**BOARD OF ZONING ADJUSTMENT
STAFF REPORT**

5869

Redeemed Community Church

VARIANCE REQUEST

SITE PLAN

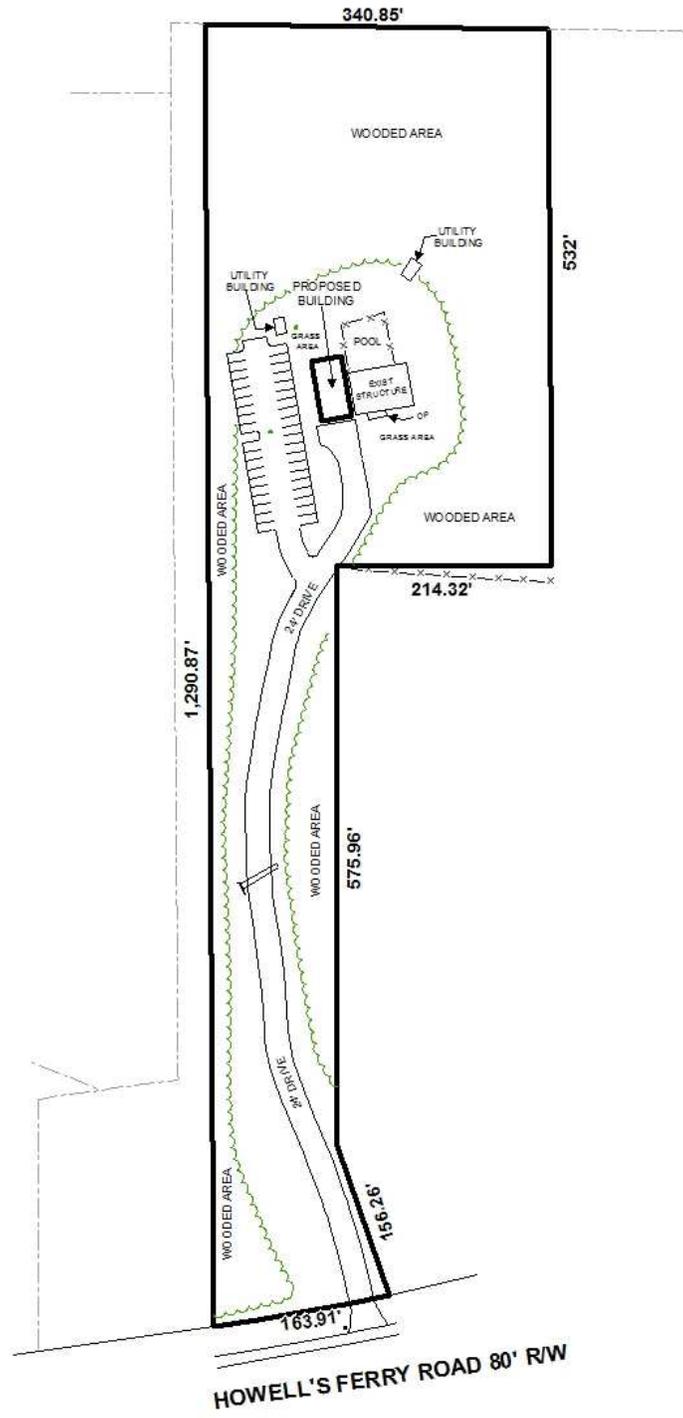
If the aggregate surfacing is approved for use as requested the applicant will need to have the following conditions met to address un-permitted land disturbing activity on-site and within the ROW: a. Submit and receive a Land Disturbance Permit for the proposed site development, b. Submit a ROW Permit for the work within the Howells Ferry Road ROW. Aggregate surfacing will not be allowed within the Howells Ferry Road ROW.

If approved, three conditions should apply: 1) Aggregate surface for driveway should not extend into the right-of-way. A city standard curb-cut is

required. 2) Parking spaces should be delineated by curb stops, as spaces can not be painted on aggregate surface. 3) Handicap parking spaces, as required, must be of appropriate surface material to provide accessibility to the building, including an accessible route from the space(s) to the building.

Access road must be at least 20ft wide, asphalt or concrete, 75,000lbs weight load, adequate turn around as stated in 2009 IFC, sec 500, and Appendix D. A fire hydrant or building sprinklers may also be required.

The site plan submitted indicates a compliant 24' wide driveway leading from Howells Ferry Road to the parking area, which would have compliant access and maneuvering area with an aggregate surface. The distance from Howells Ferry Road to the parking area is approximately 900', and the applicant states that to pave the drive and parking area would be very expensive, and the parking area may need to be relocated to allow any future expansion if the church grows beyond its current 150 members. The reason aggregate is not an approved surface is because of the possibility of the aggregate shifting onto the right-of-way and adjacent properties via tires, and parking spaces are not readily delineated. In cases where the basis for a Parking Surface Variance has been the fact that tracked or large off-the-road-tired construction equipment could adversely impact the surface due to crushing and/or chipping, a surface variance has been justified. In this instance, the applicant has not illustrated that a literal interpretation of the Zoning Ordinance would impose a hardship, and the Board cannot consider economic hardships as a basis for justification. Also, the Fire Department comments indicate that a paved driveway of compliant design would be necessary for emergency vehicle access. Therefore, the Board should consider this request for denial.

It should be pointed out that the Americans with Disabilities Act may require the provision of wheelchair accessible parking, which may consequently require some asphalt or concrete paving. The design professional should verify ADA parking requirements and revise the site plan accordingly.

With regard to the Tree Planting Variance request, the applicant states that the site is a large parcel with thick wooded areas that exceed the City's requirements. However, the site plan identifies only one 24" Oak tree to remain and simply indicates wooded areas without any tree count or specific tree identifications. Therefore, no determination can be made as to what tree credits may be allowed and what trees may still be required to be planted on site. Since there are no specifics by which to base meeting tree planting requirements, and as the applicant has not illustrated that a literal interpretation of the Zoning Ordinance would impose an unnecessary hardship, the Board should consider this request for denial.

Based on the preceding, this application is recommended

for denial.
